# RESPONSE TO JUPITER WINDFARM ENVIRONMENTAL IMPACT STATEMENT

## REGARDING THE SOIL AND WATER IMPACTS SECTIONS OF THE STATEMENT.

This report has been prepared in response to the Jupiter Windfarm Environmental Impact Statement (EIS) that was prepared by ERM Pty. Ltd. on behalf of EPHYC Pty. Ltd who is the proponent of the Windfarm Project.

This report was prepared by Wayne Cook, Environmental Consultant, Soil and Landscape Management, ABN 62517080748, at the request of the Nash Family.

Figure 1. WTG's within Duckfield Hut Soil Landscape (Aqua circles). Note the significant sheet and gully erosion. Also note erosion visible in the Sight Hill soil landscape.

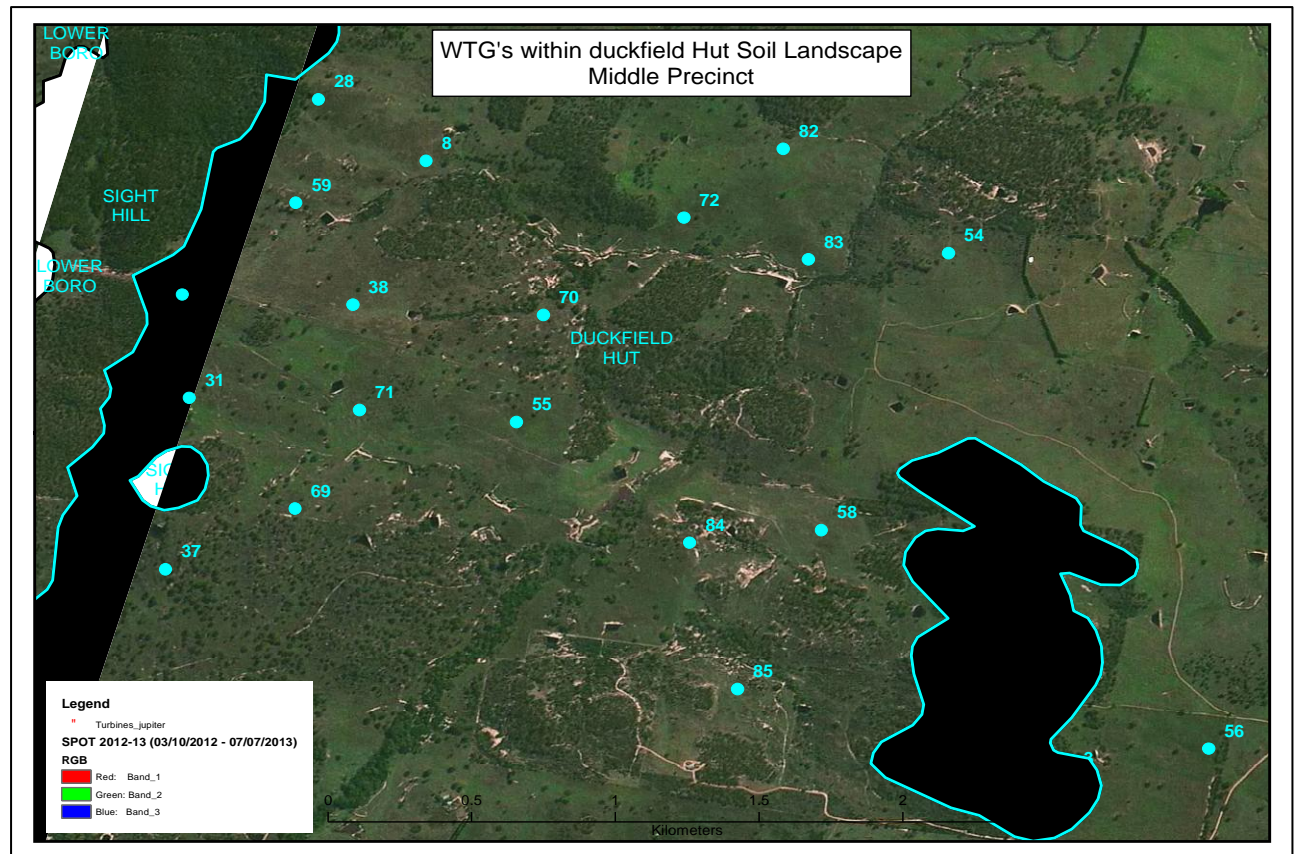
In Figures 1 and 2, severe soil erosion is clearly evident. Soil erosion is in the form of moderate to severe gully erosion and moderate to severe sheet and rill erosion. The majority of the soil erosion occurs within drainage lines however sheet and rill erosion is also evident on slopes and ridges. In general WTG's will not be constructed within drainage lines however access tracks and transmission line trenching will traverse significant numbers of drainage lines.

As can be seen in Figure 1, the Sight Hill Soil Landscape is also erodible, especially when disturbed. Jenkins (1996) notes that minor sheet erosion is common and widespread in the Sight Hill Soil Landscape. Of note is the fact that the Sight Hill Soil Landscape contains erosive soils within the Jupiter P.A. in the vicinity of proposed WTG sites.

*Figure 3. Sight Hill Variant A Soil Landscape showing WTG's 4, 6 and 32. Note the severe soil erosion evident in this area. Also note the high density of soil conservation works in the vicinity of the proposed WTG sites.*

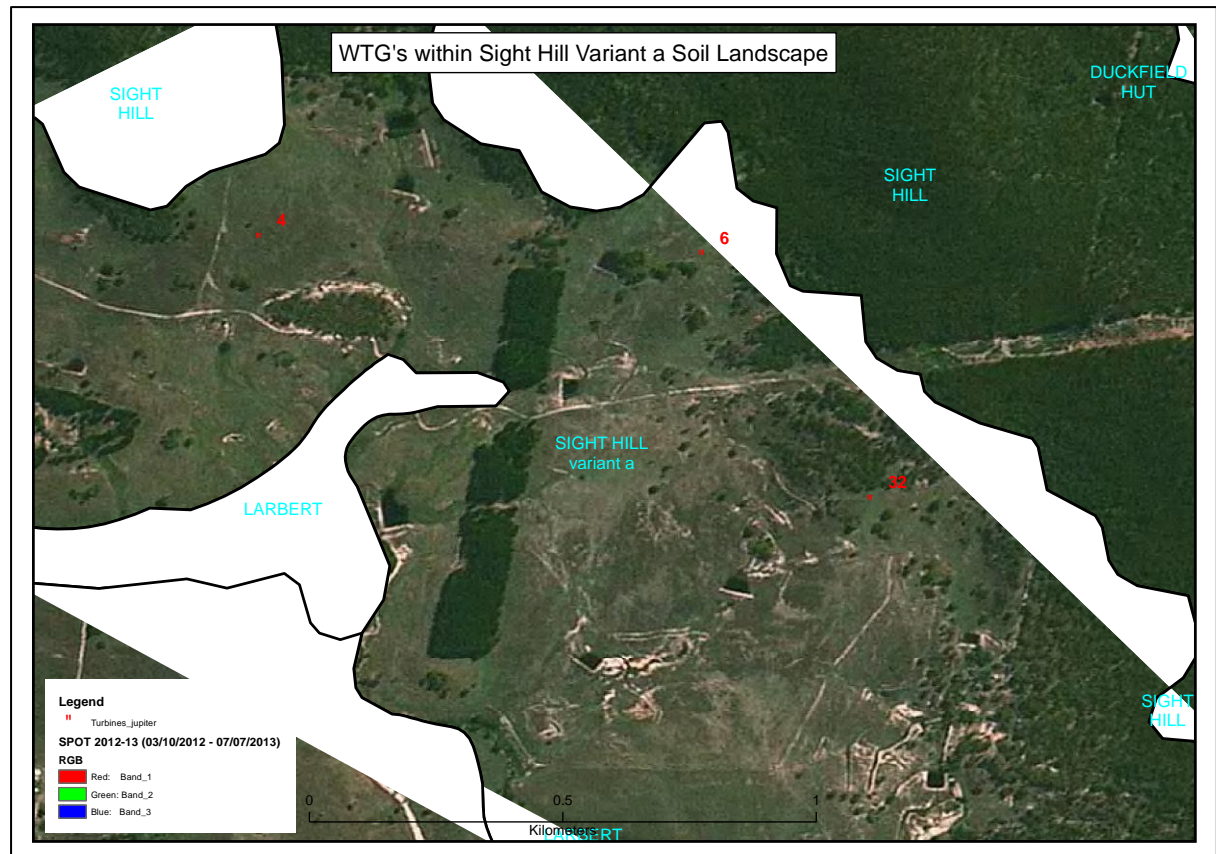
Three proposed WTG locations indicated in Figure 3, are located in the Sight Hill Soil Landscape "Variant a", Jenkins states that saline scalds are common in this Soil Landscape variant. As can be seen in Figure 3, severe soil erosion exists in the area of the 3 proposed WTG sites. Soil conservation works are evident in many of the drainage lines indicating soil salinity and possibly soil sodicity. A high risk of soil erosion is evidently present in areas that the Jupiter project will have an impact on in the form of access roads and trenches for power distribution.

The author suggests that due to existing erosion in this area, that these three WTG's as proposed may prevent unacceptable soil and water impacts. As can be seen in the Figure 3, even where soil conservation works have been installed, regrowth of vegetation has not occurred successfully on areas disturbed by machinery. Regeneration of disturbed soils in sodic and saline areas is difficult and unless the nature of the soils is understood and carefully managed, continued erosion will occur as evidenced in figure X.

*Figure 4. Lower Boro Soil Landscape showing serious gully erosion and significant areas of soil conservation works. Illustrating the high risk of soil erosion if disturbed. Soils tend to be sodic.*

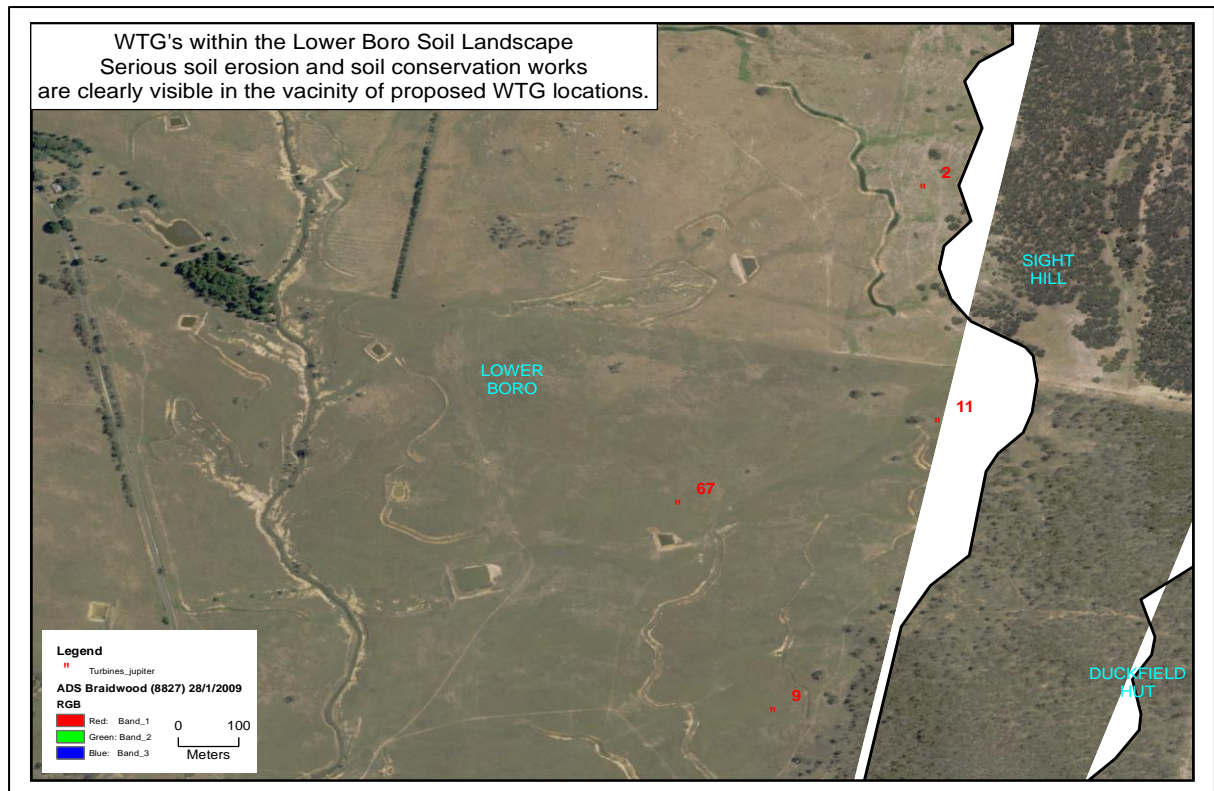
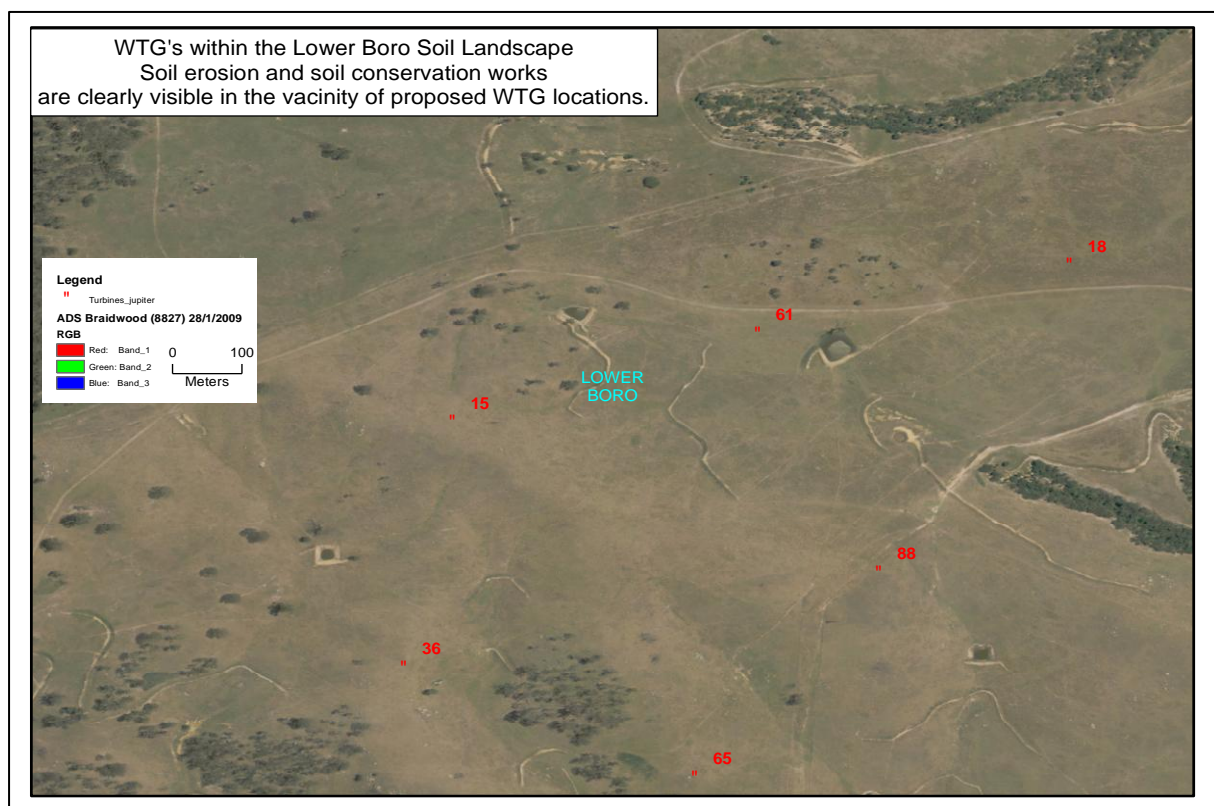
Many of the proposed WTG sites located within the Lower Boro Soil Landscape, are near soil conservation works (see Figures 4 and 5). Considerable care will be required when conducting engineering works of any kind in the Lower Boro Soil Landscape, in order to avoid soil erosion impacts.

*Figure 7. Illustration of the Nash Family Property showing property boundary in red. Aqua line is catchment draining to Nash Property from Jupiter project area. Access tracks and WTG sites are shown.*

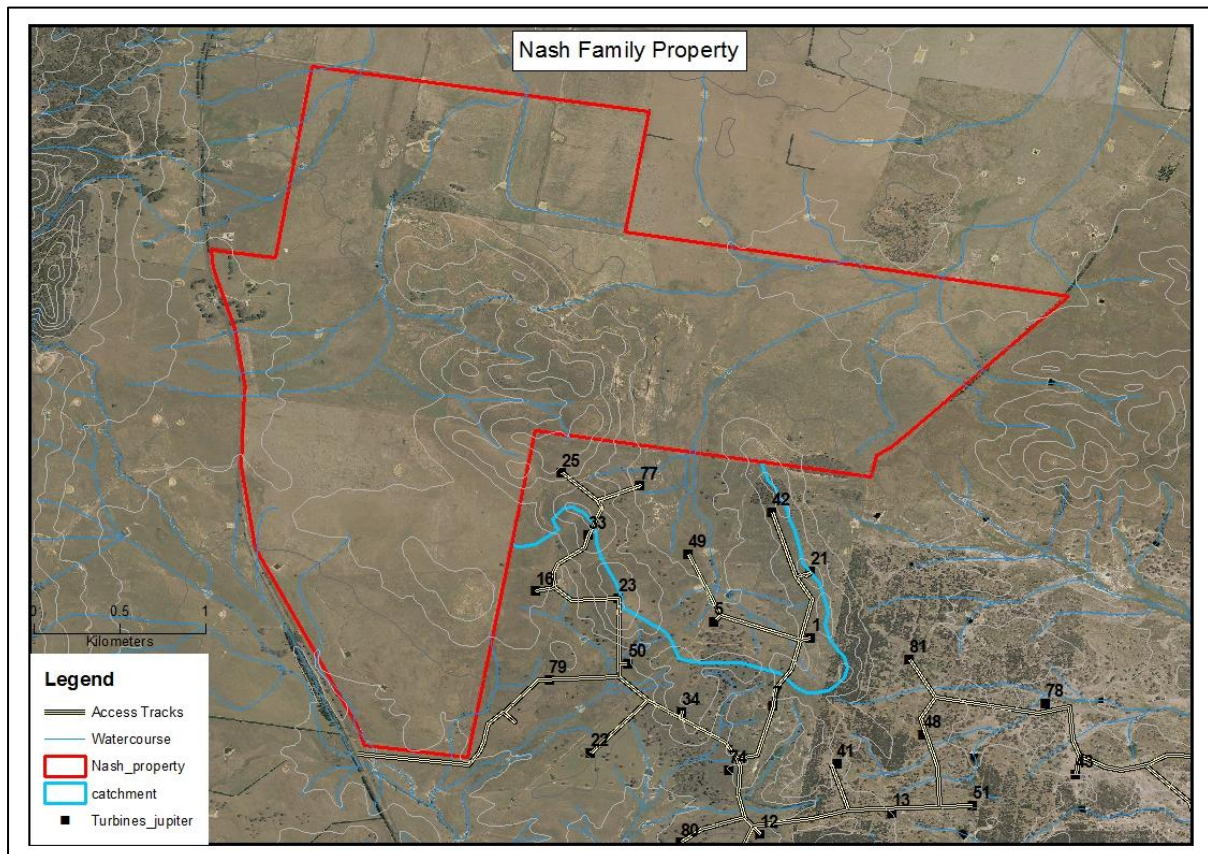
Part of the northern sector of the Jupiter project incorporates the headwaters of the Chain of Ponds Creek and an unnamed sub-catchment of the Mulwaree River. The area within the P.A. that drains directly to the Nash property is calculated to be 132 Hectares (Figure 7).

Figure 7 shows that there are 7 WTG sites located within the 132 Hectares of the Jupiter Project that will drain directly into the Nash property. Given that the proponent only has to indicate within 100 m actual site locations, there could actually be 8 WTG in the catchment. However calculations are based on 7. Combined with the access tracks and crane hardstands I calculate the footprint within the 132 hectares draining to the Nash property to be 3.58 hectares.

Therefore a total of 3.58 hectares of impermeable surface will be added to the catchment that drains to the Nash property. The additional impermeable surface created by the Jupiter Project could have a negative impact upon the water quality of the stock water dams, essential to the successful operation of the Nash cattle grazing enterprise.

Figure 10. Image showing proposed access track routing across contour.

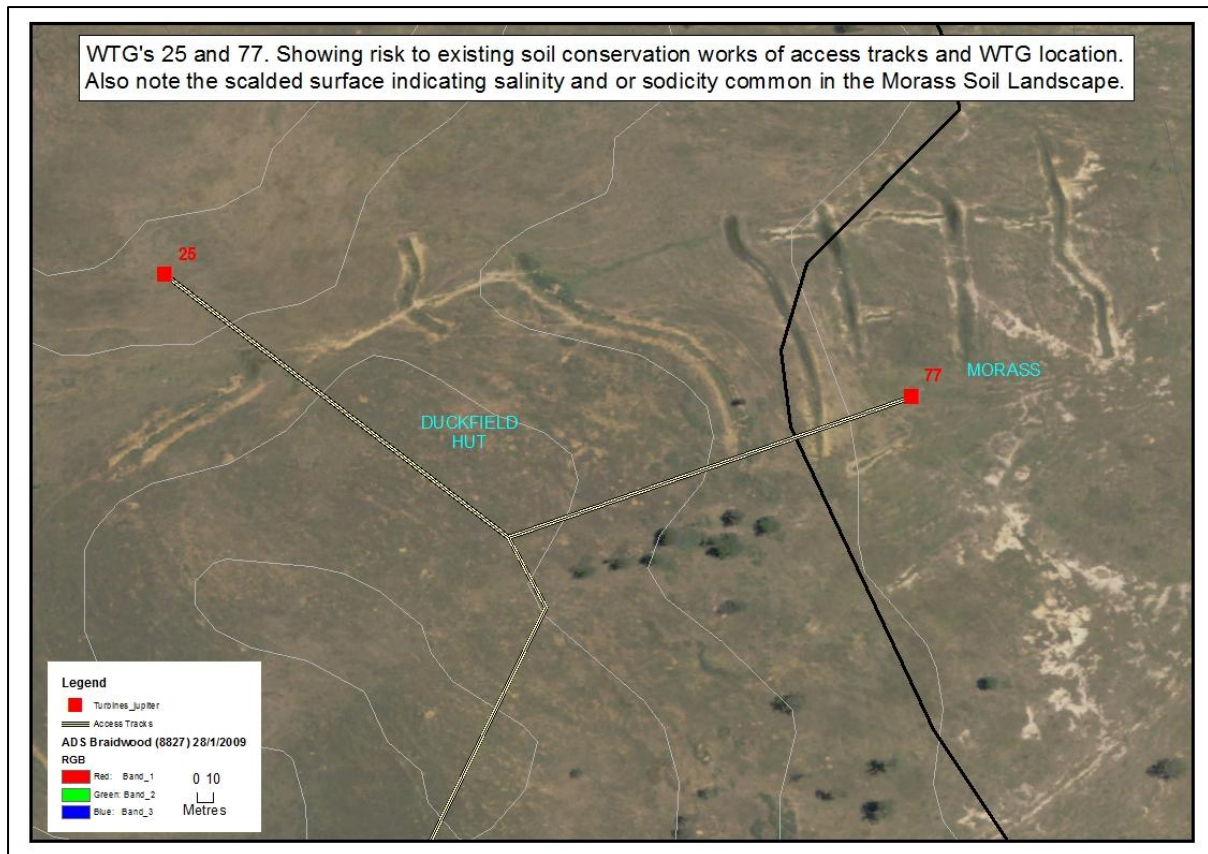
The proposed access road to WTG 77 is shown to go directly down slope and will cross existing soil conservation contour banks. Such a routing of the access track will lead to concentrated flows directly into an area already subject to extensive soil erosion issues.

Proposed routing of the access track to WTG 25 will also cross contours on 2 slopes and will when combined with added flow from the pad and crane hardstand, potentially add considerable flow to the drainage line flowing past WTG 77. As is shown in figure 10 the drainage line is already at risk of eroding through the existing soil conservation contour banking.
